REV.
B

AS9554

<p>SAE Aerospace An SAE International Group</p>	<p>AEROSPACE STANDARD</p>	<p>AS9554 SHEET 1 OF 2</p>	<p>REV. B</p>
	<p>SCREW, MACHINE - DOUBLE HEXAGON EXTENDED WASHER HEAD, CORROSION AND HEAT RESISTANT STEEL, UNS S66286, 130 KSI MIN, .1380-40 UNJF-3A</p>

ISSUED 2000-08 REVISED 2006-05

FIGURE 1 - SCREW

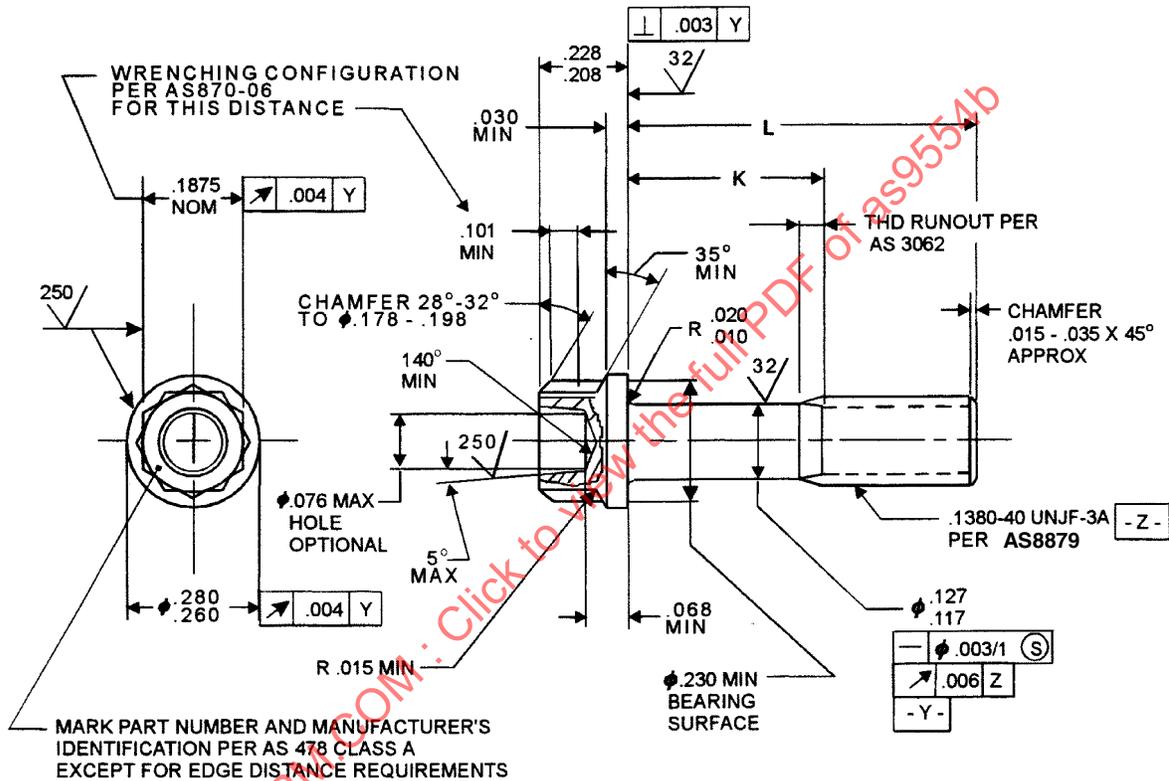
ADD DATUM REQUIREMENTS FOR -.02 THRU -.10 LENGTHS (NEW NOTE 1) AND REVISE THREAD SPEC TO AS8879.
